Final Main Installation Focused Feasibility Study Report

Defense Depot Memphis, Tennessee U.S. EPA I.D. Number TN4210020570

July 2024

U.S. Army Corps of Engineers, Mobile District Contract No. W91278-16-D-0061 Task Order No. W9127819F0535

1' SOUTH

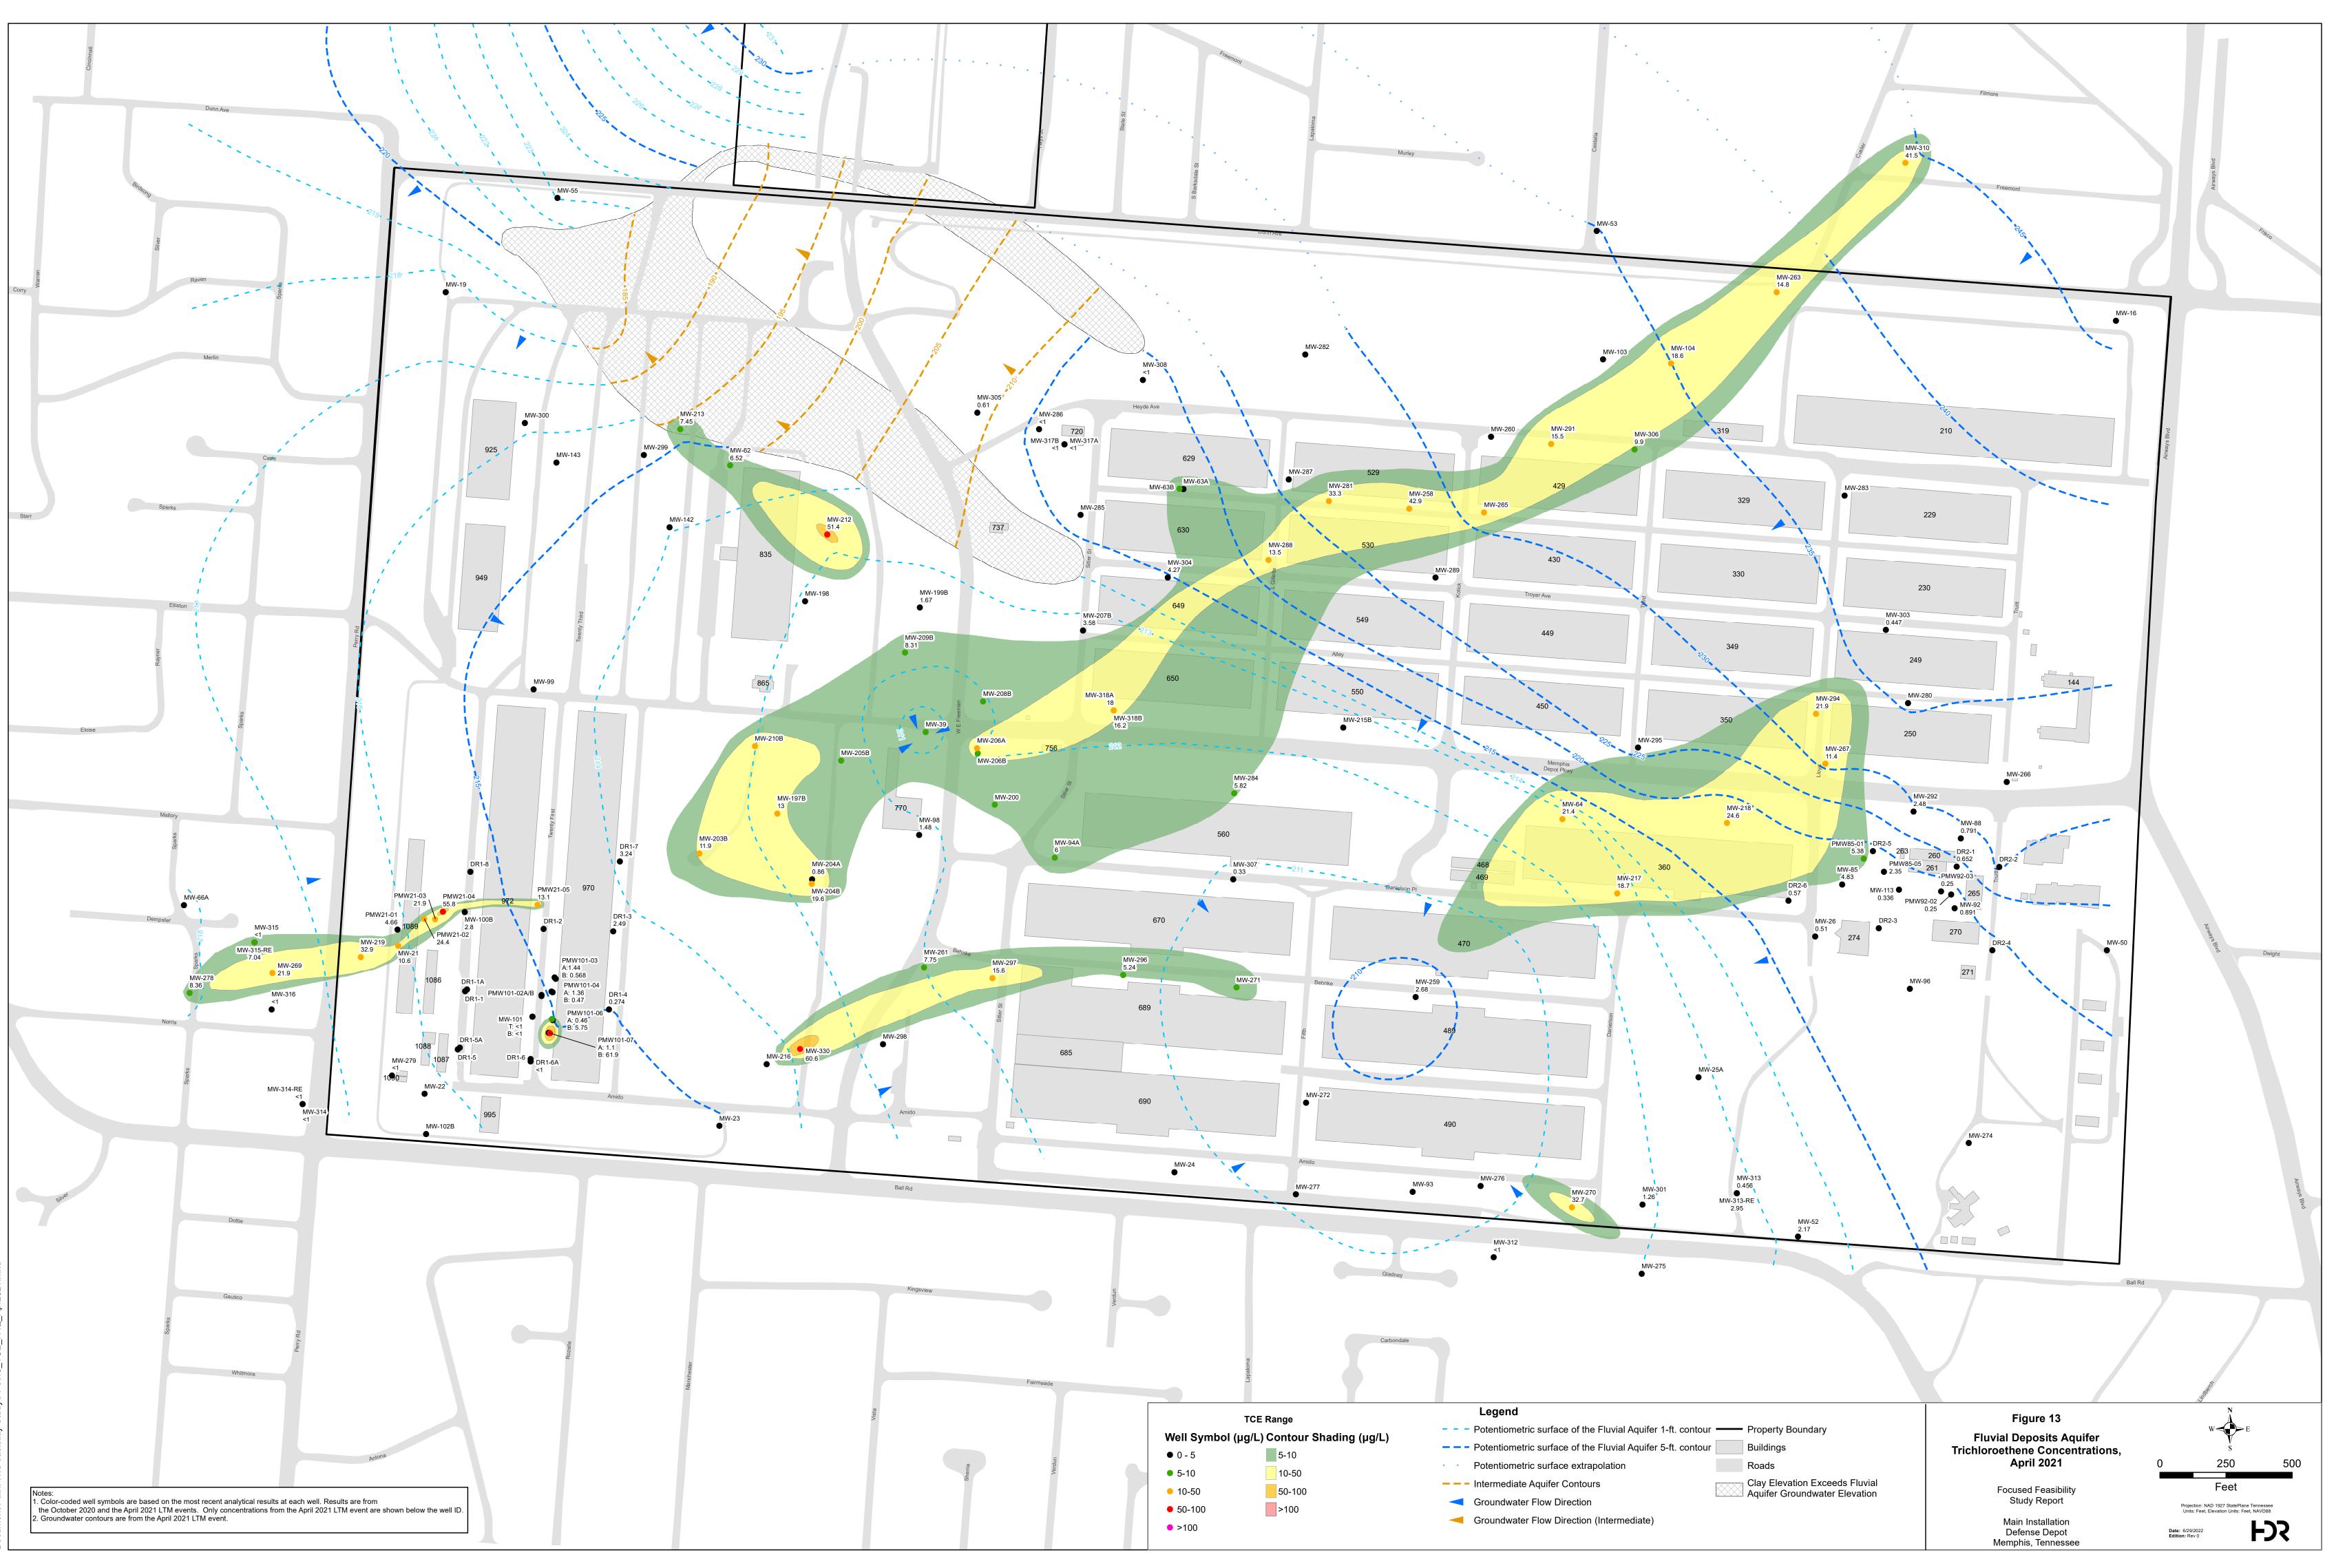
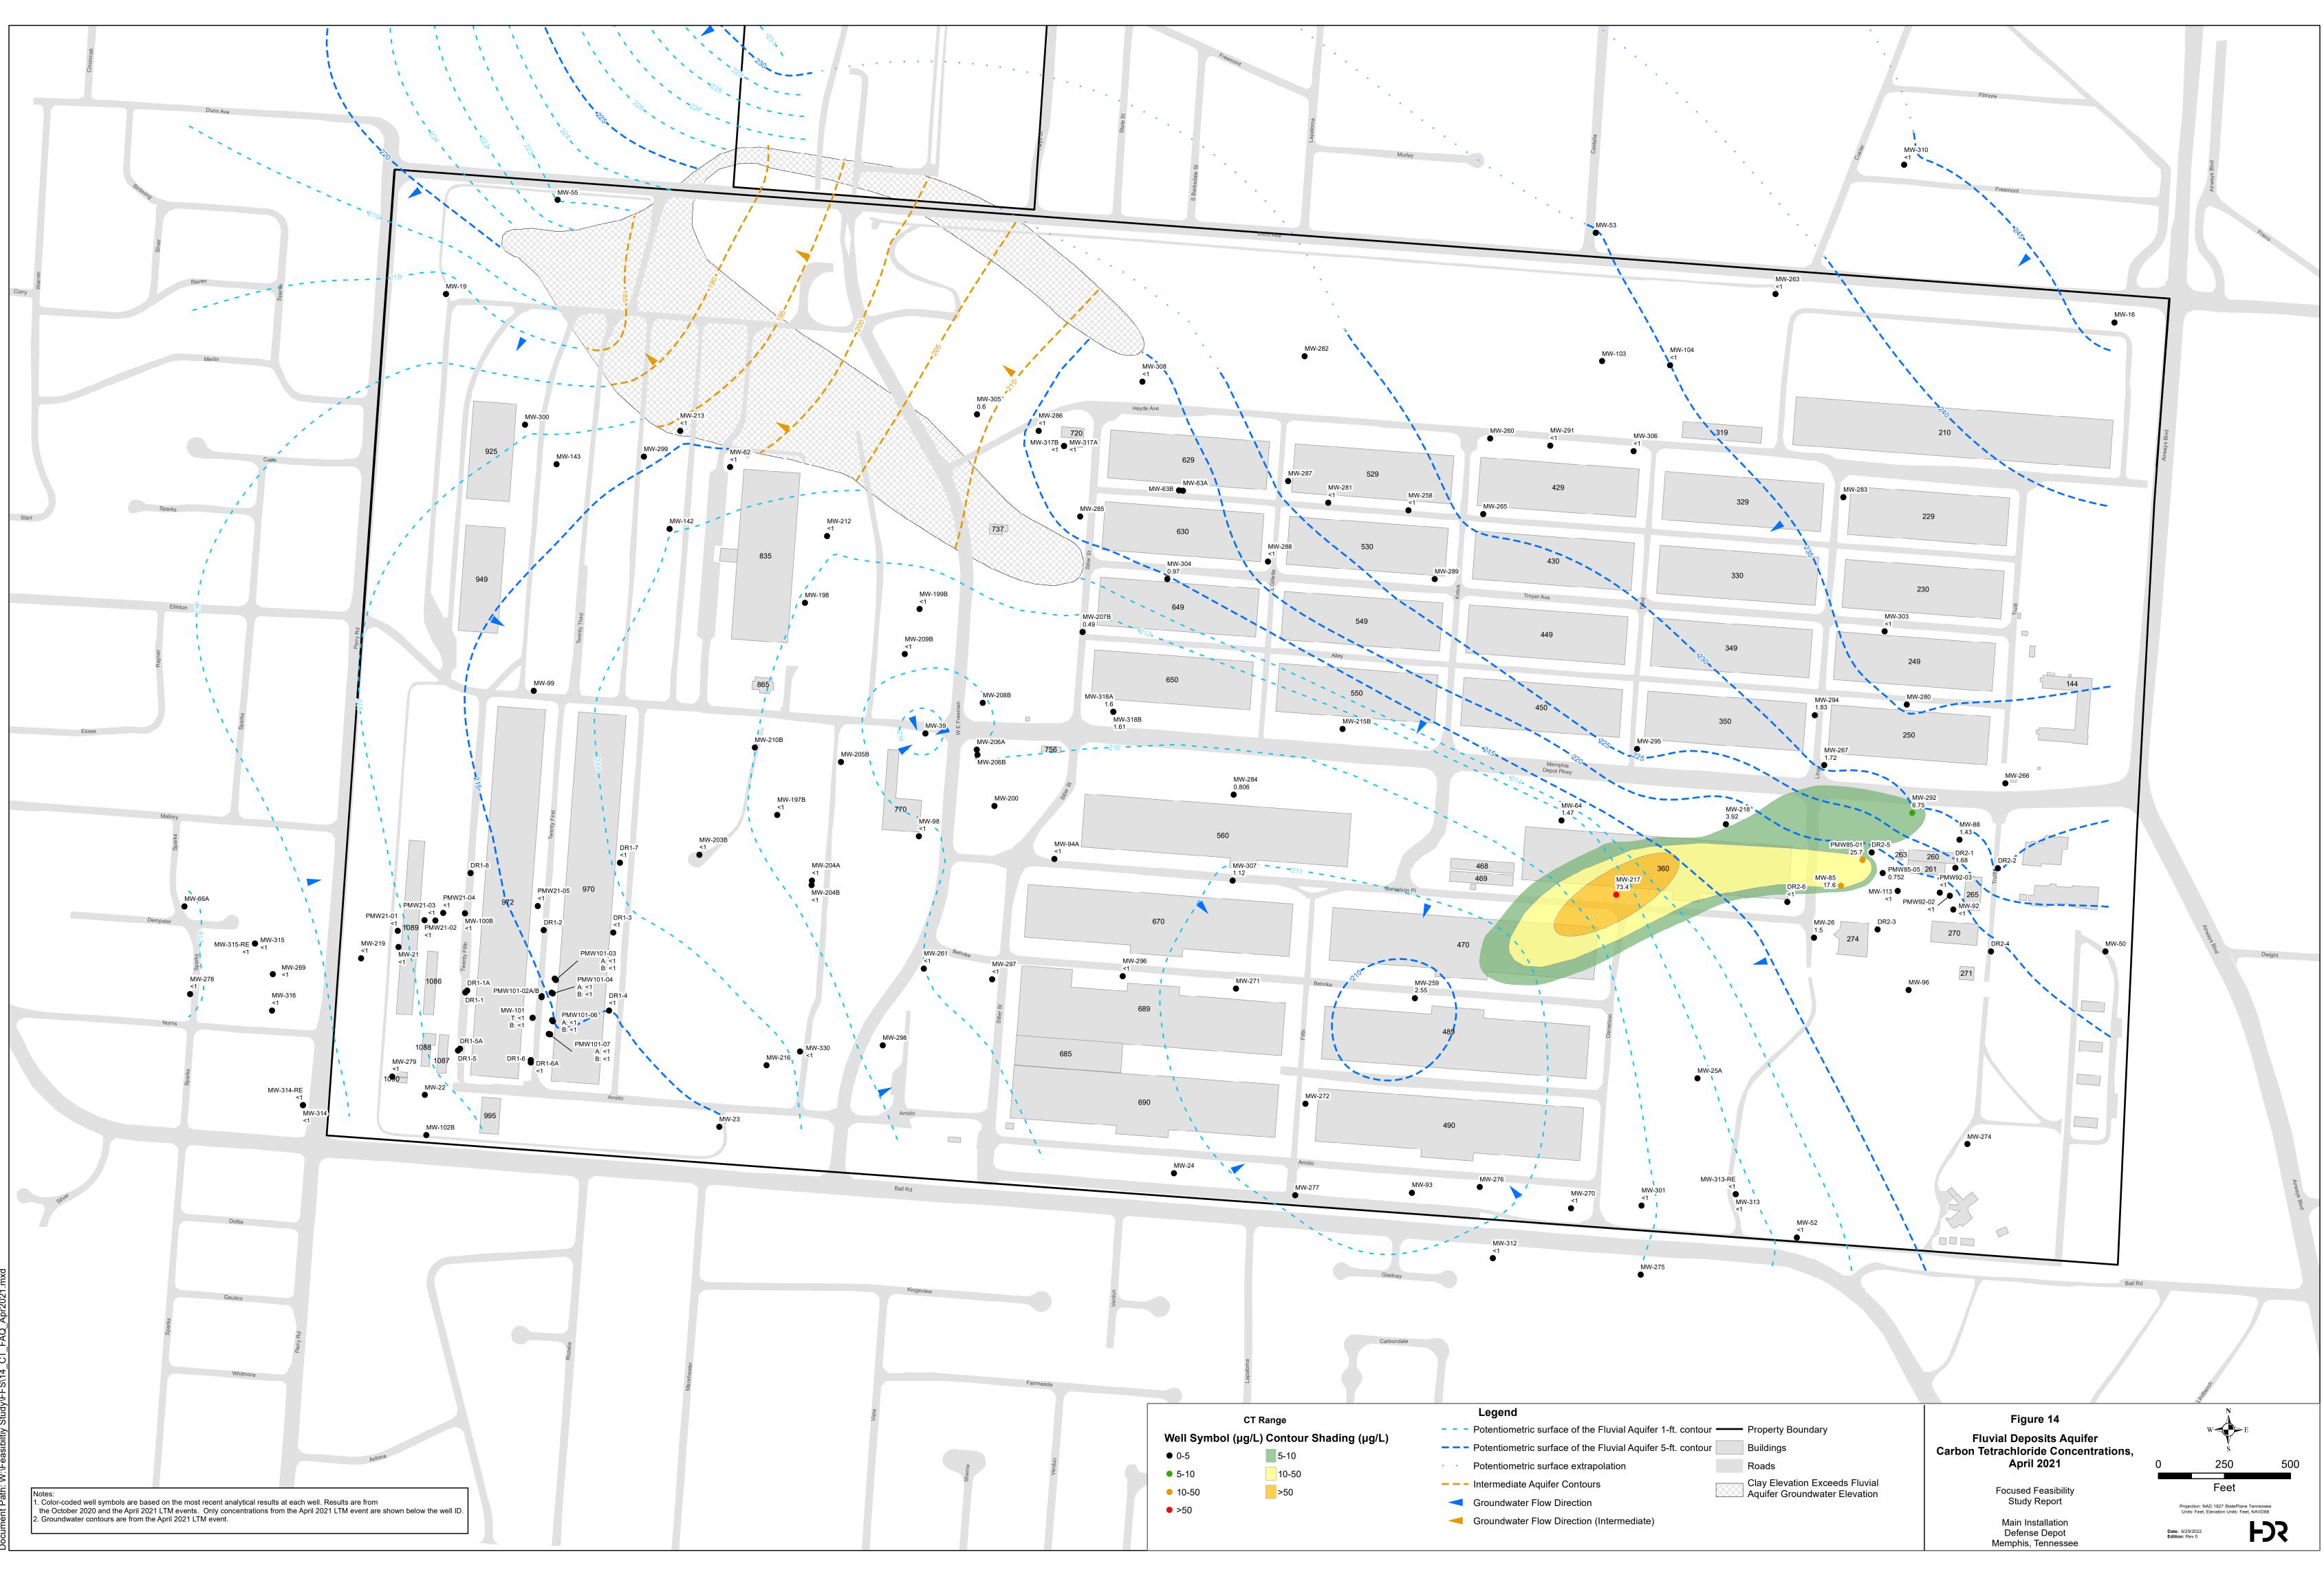
Moreover, Figure 18 shows chlorinated VOC detections in the Memphis Sand Aquifer. As part of the monitoring plan, downgradient monitoring locations will need to be installed.

- 12. Section 1.2.6.2.8, Hydraulic Connections IAQ and MAQ, Page 1-15: The final sentence of this section states that there is no plume in the MAQ; however, according to Figure 18 (Memphis Aquifer CVOC Concentrations, April 2021) tetrachloroethylene (PCE) was detected above the USEPA Maximum Contaminant Level (MCL) of 5 μg/L in monitoring wells MW-254 and MW-140, which are in the northeast portion of the MI. It should be noted there is no MAQ well to the southwest to bound these PCE exceedances. Based on the proximity of MW-254 and MW-140, a potential undefined PCE plume appears to be present in the MAQ in the northwest portion of the MI. Please revise the text to discuss this potential PCE plume in the MAQ.

12. Section 1.2.6.2.8, Hydraulic Connections – IAQ and MAQ, Page 1-15: The final sentence of this section states that there is no plume in the MAQ; however, according to Figure 18 (Memphis Aquifer CVOC Concentrations, April 2021) tetrachloroethylene (PCE) was detected above the USEPA Maximum Contaminant Level (MCL) of 5 μg/L in monitoring wells MW-254 and MW-140, which are in the northeast portion of the MI. It should be noted there is no MAQ well to the southwest to bound these PCE exceedances. Based on the proximity of MW-254 and MW-140, a potential undefined PCE plume appears to be present in the MAQ in the northwest portion of the MI. Please revise the text to discuss this potential PCE plume in the MAQ

As stated in Response SC5, contaminant concentrations in the MAQ in the downgradient area of the plume, within the erosional window, are only slightly above the MCL. Concentrations in upgradient wells in the MAQ and lower IAQ are not significantly higher (see Figure 10 of the FFS). Groundwater modeling estimated concentrations would decrease below 1 μ g/L within approximately 2,000 ft from the MI. Response SC5 states that active remediation at Building 720, within the window, will "reduce concentrations in downgradient wells including MAQ wells ...".
